**INFORMATION LETTER 205-03-33
212-03-53
412-03-52
UH-1H-II-03-16**

SUBJECT: P/N 214-070-300-001/-101 Internal Rescue Hoist Cable Cutter and Pyrotechnic Cartridge

SUBJECT: Product Improvement - Replacement of Cable Cutter Assembly, Part Number 42277-336 with Part Number 42305-160.

Rescue Hoist Cable Cutter Assembly, 42277-336
Figure 1

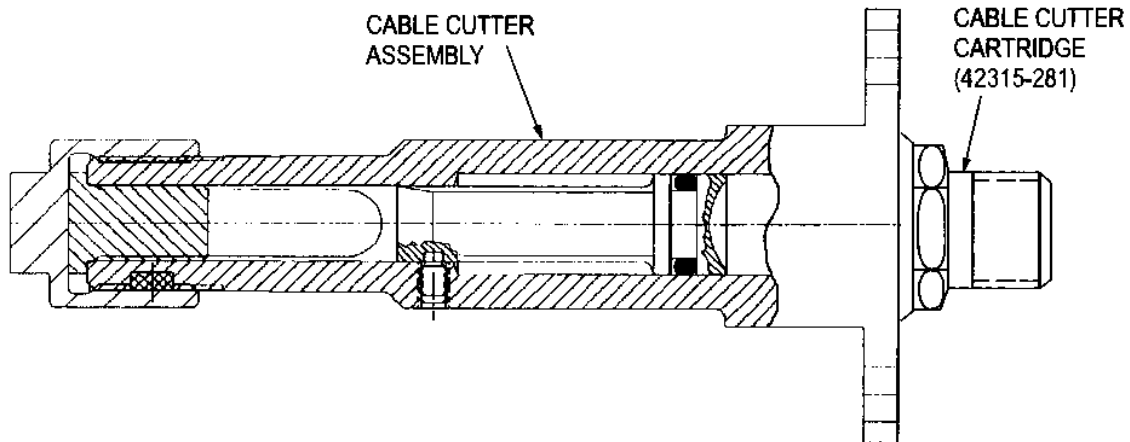
- (1) This Service Information Letter is to inform operators of the TRW Rescue Hoist models 42277-1, 42305-1, and 42305-2, that the existing cable cutter assembly, Part Number 42277-336, see Figure 1, will no longer be available for purchase and will not be supported after January 2003.
- (2) An improved cable cutter assembly, 42305-160 is available as the replacement. This new assembly is a solid piece design that is fabricated from a higher strength stainless steel, see Figure 2. The new cable cutter assembly uses the Mark 44 Mod O cable cutter cartridge, which has a greater resistance to high EMI potentials.
- (3) The new cable cutter body is interchangeable with the old cable cutter.

- (1) TRW Aeronautical Systems recommends that when the existing cable cutter cartridges 42277-231 have exceeded the manufacturer's shelf life or have been fired, that the cable cutter assembly and cable cutter cartridge be replaced with the new one.
- (2) The new cable cutter assembly, 42305-160 and cable cutter cartridge, 42315-281 (Mark 44 Mod O) may be purchased from TRW Aeronautical Systems. Hoist operators may obtain price and availability information by contacting the following:
